ADDENDUM

PROPOSED NO WAITING AT ANY TIME PARKING RESTRICTIONS ON NUNNYKIRK CLOSE, HORSLEY ROAD AND MAIN ROAD IN OVINGHAM

22 September 2022

Drawing Number: H0210097/00/C254/10/01 Revision: A

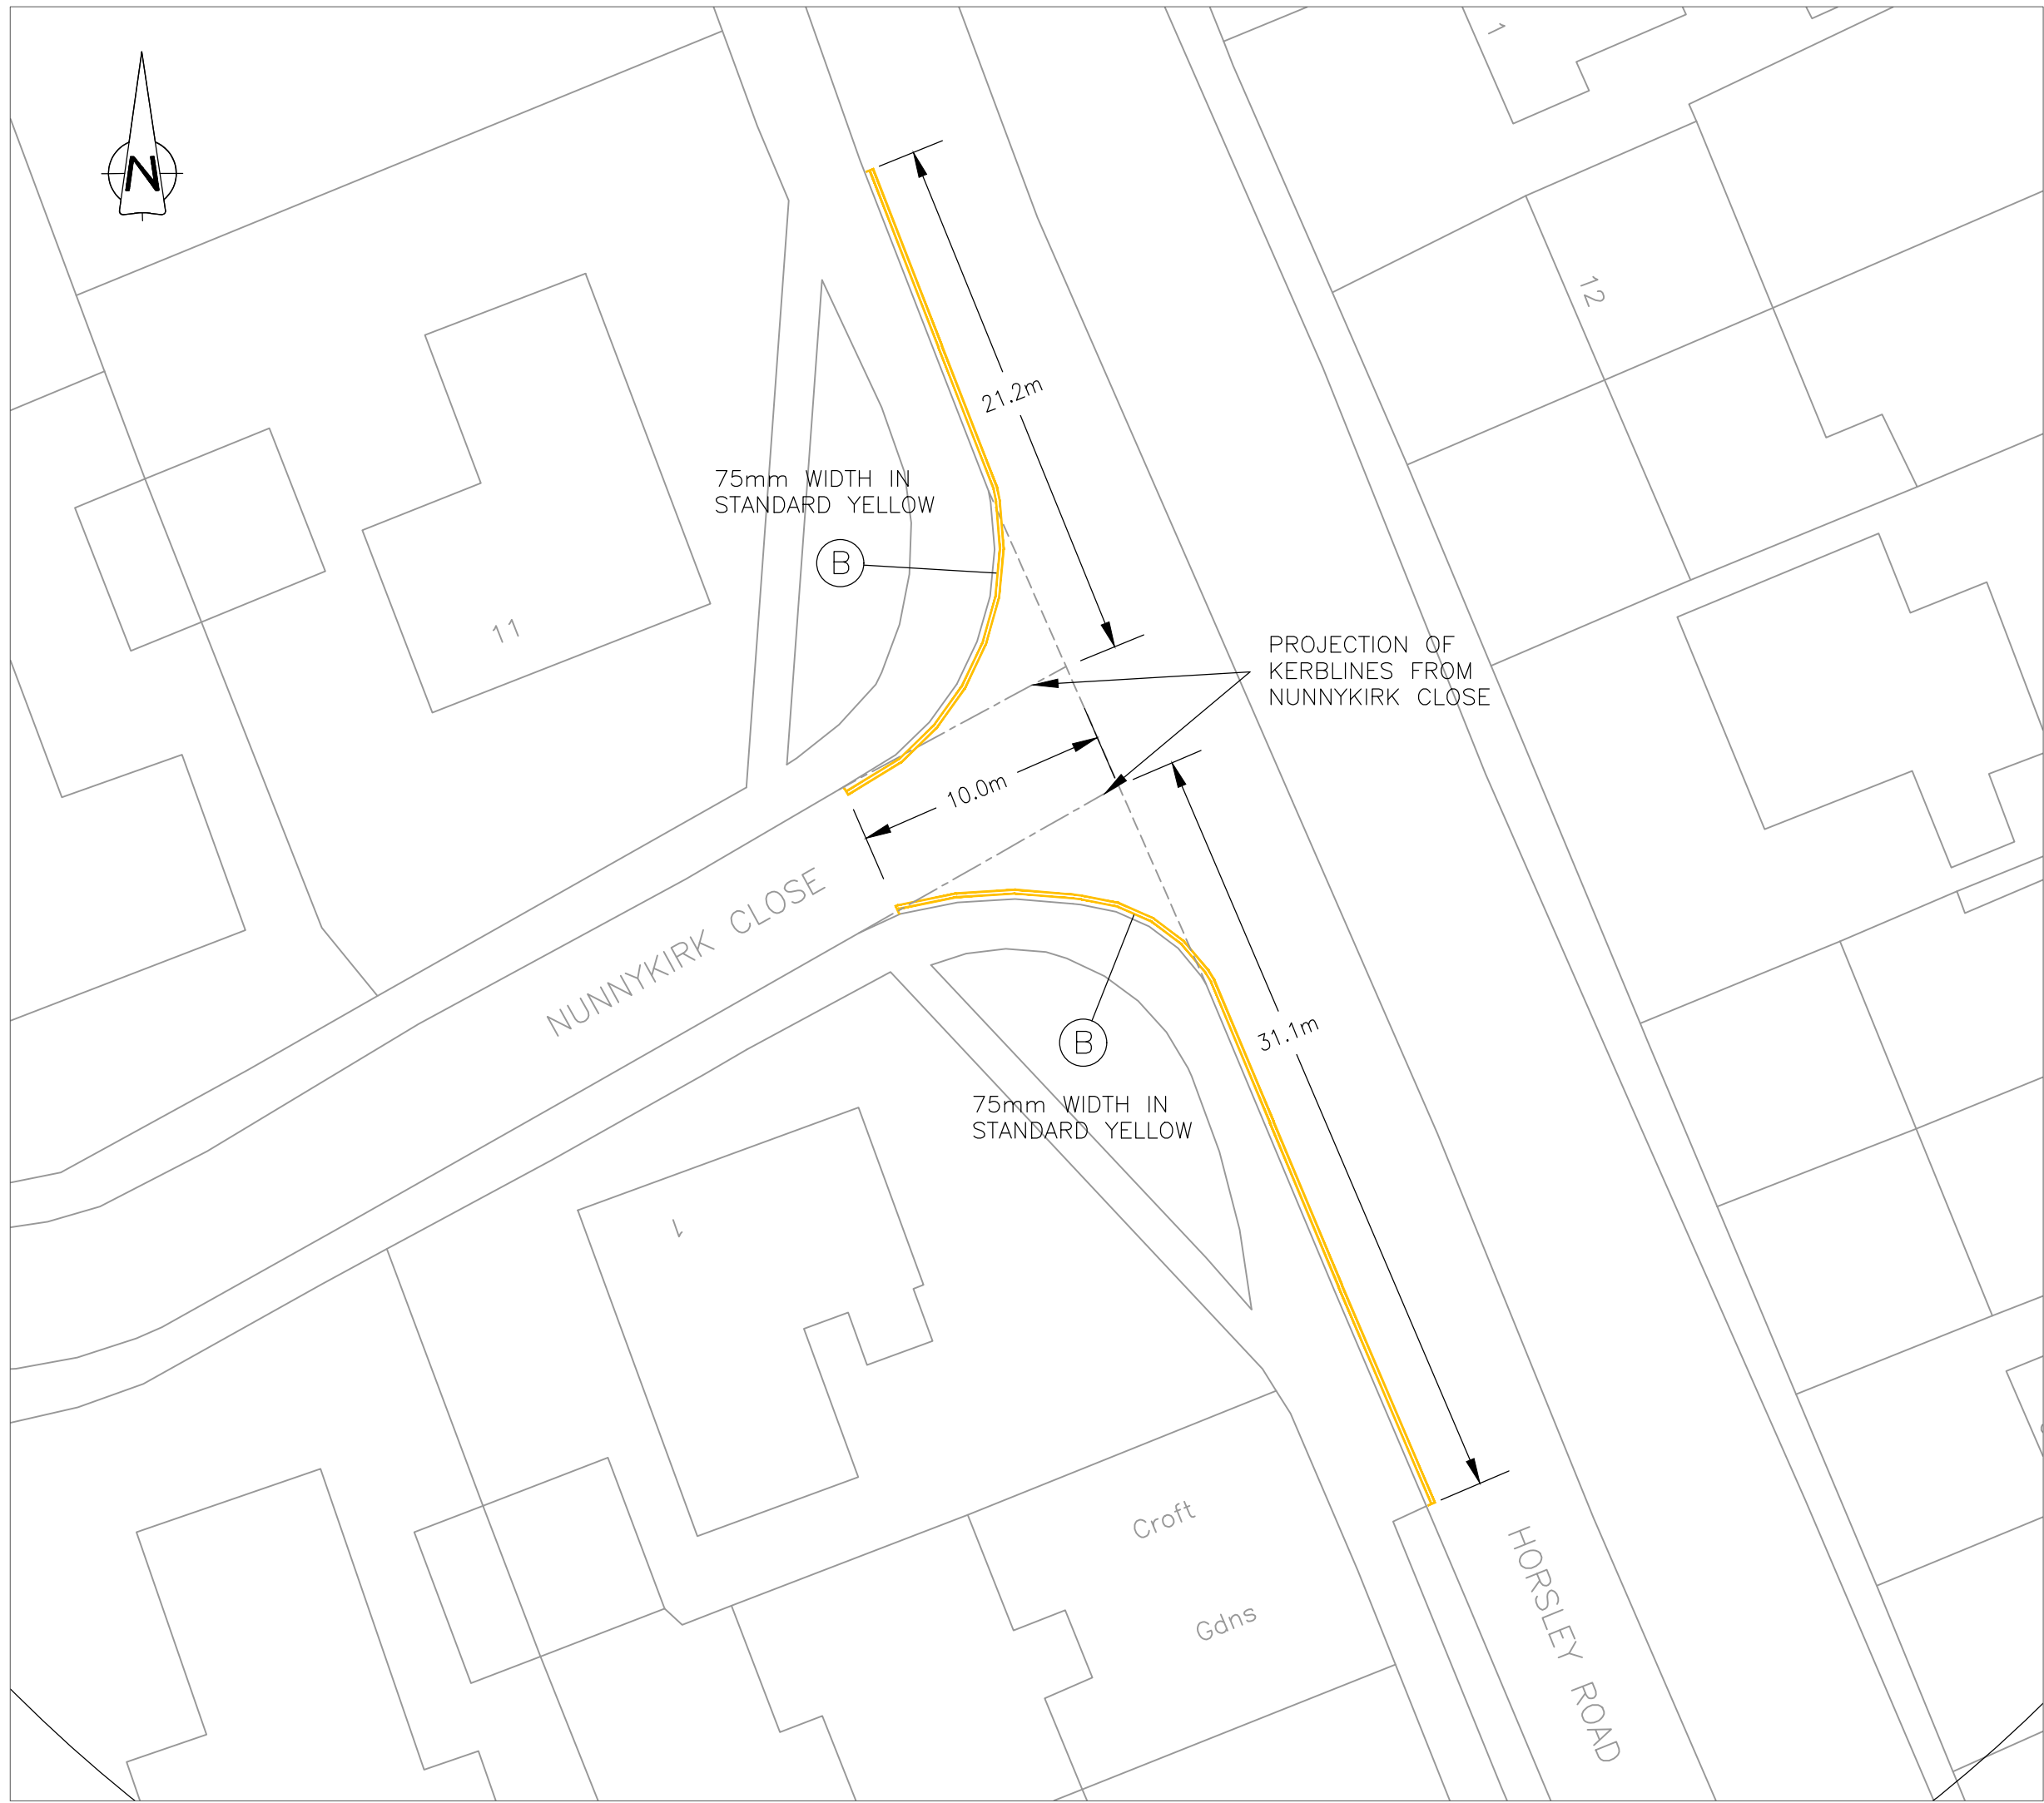
Further discussions were held between Councillor Waddell and NCC Officers and it was agreed to add the additional parking restrictions requested by the Parish Council on the junction of Horsley Road and Main Road, given the positive impact it would have on road safety, combined with the minimal impact on parking availability in the area.

Decision Taken: To add Parking Restrictions at the junction of Horsley Road and Main Road. All other restrictions implemented unchanged.

LOCATION 04 – HORSLEY ROAD / MAIN ROAD
Scale 1/250

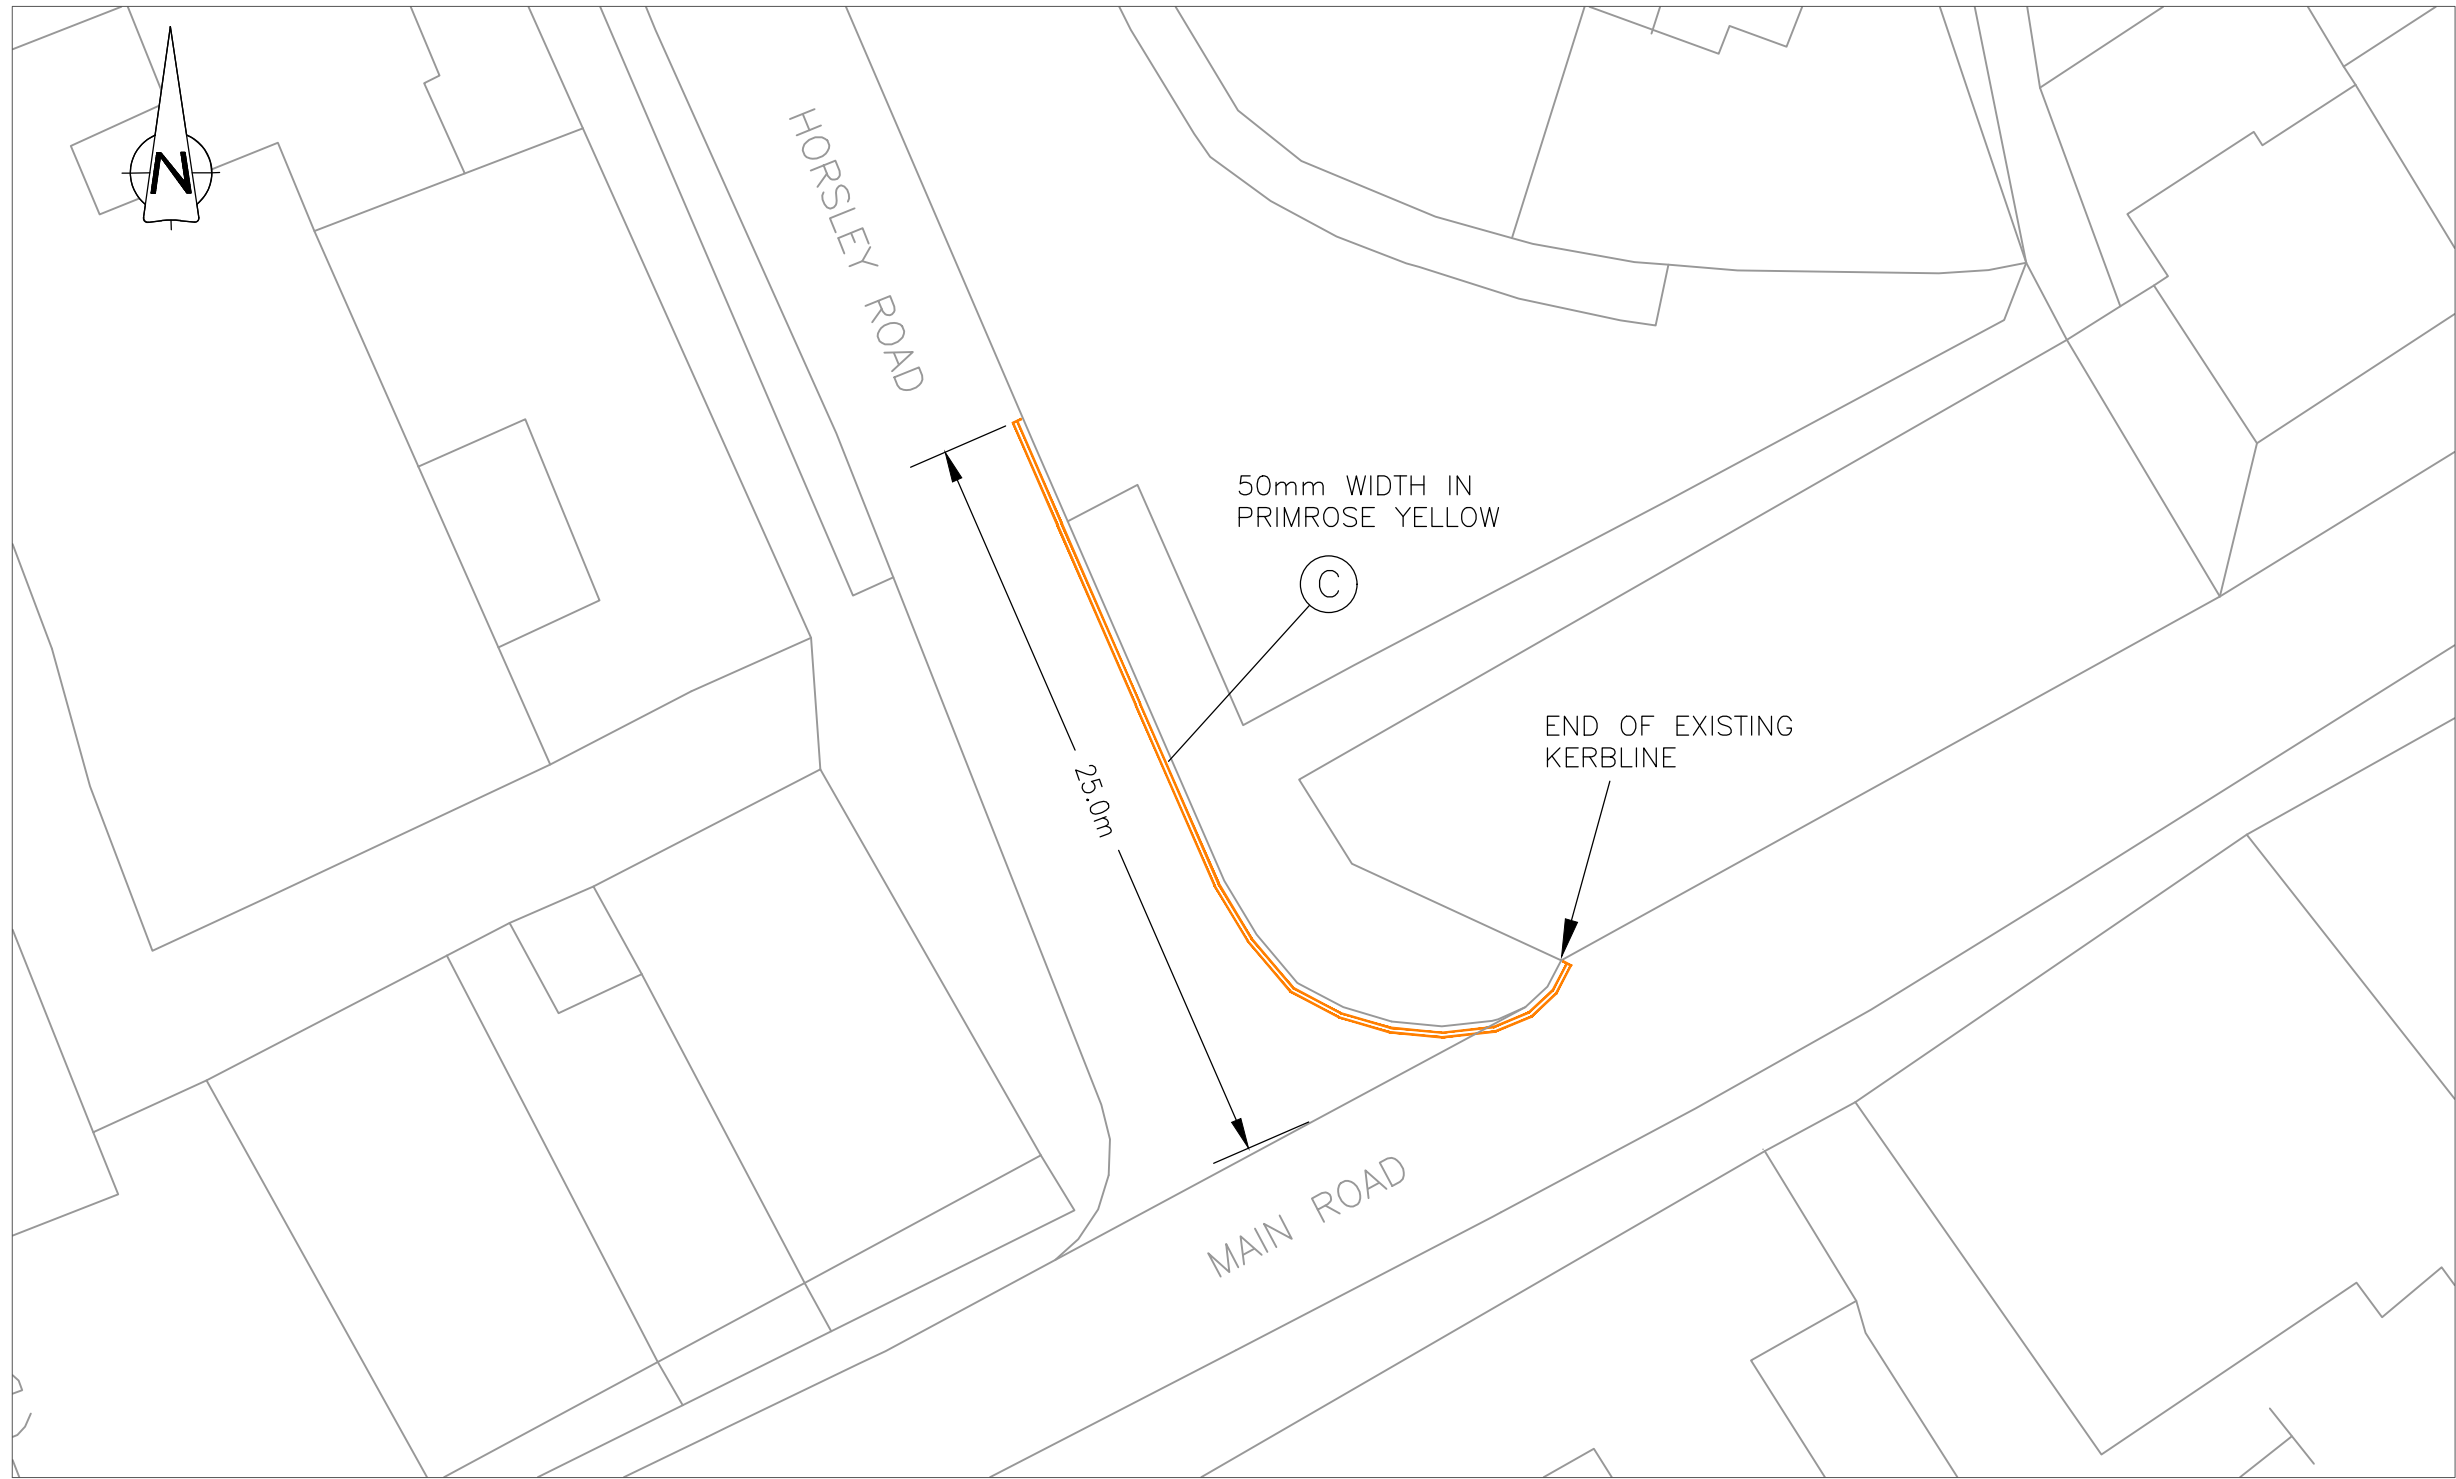
PROPOSED DOUBLE YELLOW LINES AT LOCATION 04 HORSLEY ROAD / MAIN ROAD ADDED AT REQUEST OF NCC HIGHWAYS PROGRAMME TEAM.	CH	GM	GM	15/08/2022	A
---	----	----	----	------------	---

- 1.1 ROAD MARKINGS TO BE IN THERMOPLASTIC SCREED WITH APPLIED SOLID GLASS BEADS & BE IN ACCORDANCE WITH THE TSR&GD 2016 & THE MANUAL OF CONTRACT DOCUMENTS FOR HIGHWAY WORKS – VOLUME 1 SPECIFICATION FOR HIGHWAY WORKS.
- 1.2 PROPOSED DOUBLE YELLOW LINES AT LOCATION 04 ARE TO BE LAID 50mm WIDTH IN PRIMROSE YELLOW COLOUR AS THEY ARE LOCATED WITHIN THE CONSERVATION AREA.
